AIRWORTHINESS DIRECTIVE

GROB TWIN ASTIR GLIDERS (All s/no's NOT G 103)

INSPECTION/REPLACEMENT OF DIVEBRAKE SYSTEM INTERMEDIATE BELCRANKS.

Issue 1	GFA AD 255
8/4/83	Page 2 of 3

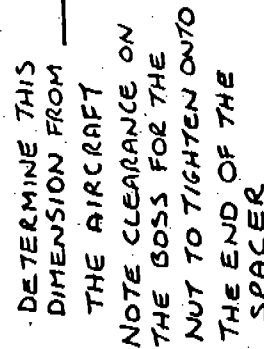
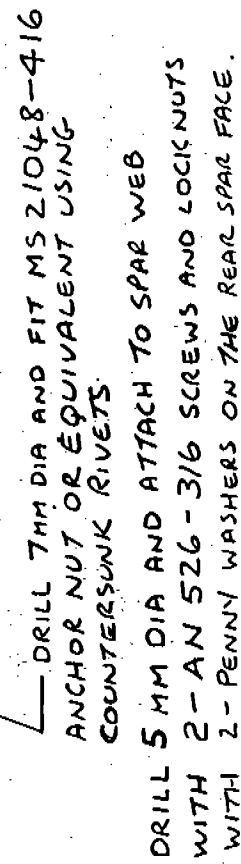
INSTALLATION RECOMMENDATION As drawn by GROB, later removal of the Bellcrank can only be carried out by re-opening the 80x120 access hole in the leading edge. On sheet 3 of this AD is a suggested scheme which provides a captive nut allowing removal of the pivot bolt, without cutting an access hole;-

- (a) Make up and fit nut retaining bracket
- (b) Replace the 6mm bolt with an AN4 bolt, reaming the spacer and bracket to suit.
- (c) Cut the spacer tube to allow removal.

- (1) Suggested scheme for nut retention and spacer removal for later servicing of Bellcrank assembly.
- (2) Make the bracket from 16 SWG mild steel - deburr and etch prime.
- (3) Replace 6mm bolt with a 1/4" American AN4 bolt reaming spacer and lug to suit.
- (4) Provision for Lockwiring the head of the bolt to provide for eventual failure of the anchor nut locking material, is recommended.

G.F.A. ISSUE B-4-83					
				1)	Tag	Name	Werkstatt Oberflächenzustand Oberflächenbesch.		
				Beauf.		WI			
				Gepr.					
				Norm					
							Benennung ZEICHNUNG 2		
And. Zust.	Änderungs-Mitteilung	Tag	Name	Zeichnungs-Nr. G 103 TM103-5-11			Erstellt von Erstellt durch

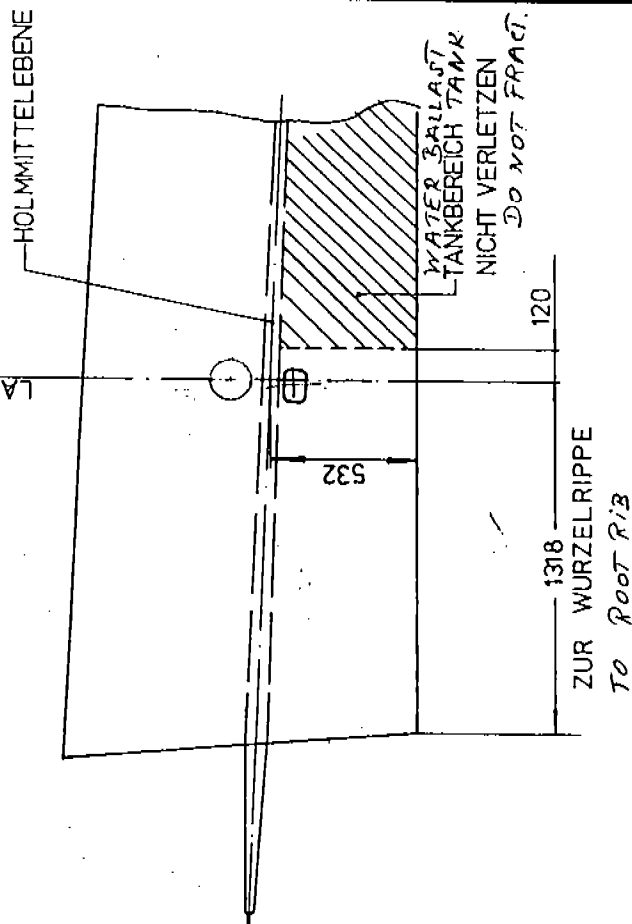
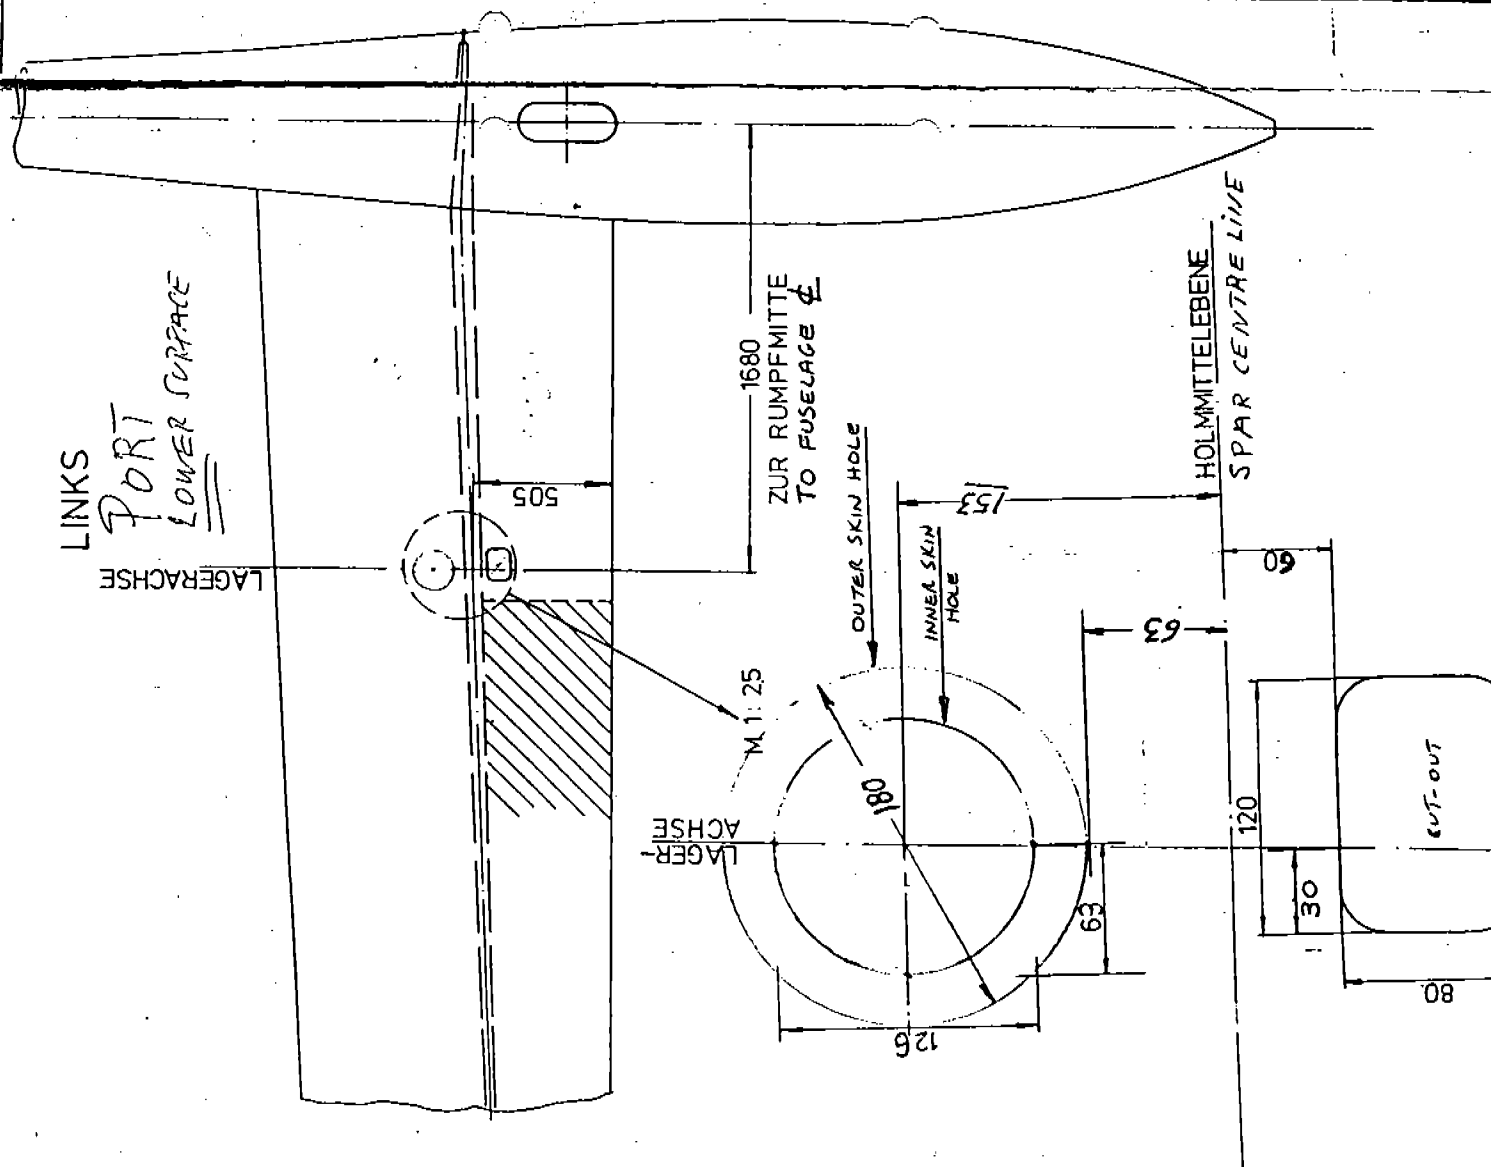
TO AVOID LOOSENING IN
SERVICE "LOCTITE" IS
RECOMMENDED TO RETAIN
SCREWS AND BOSSES
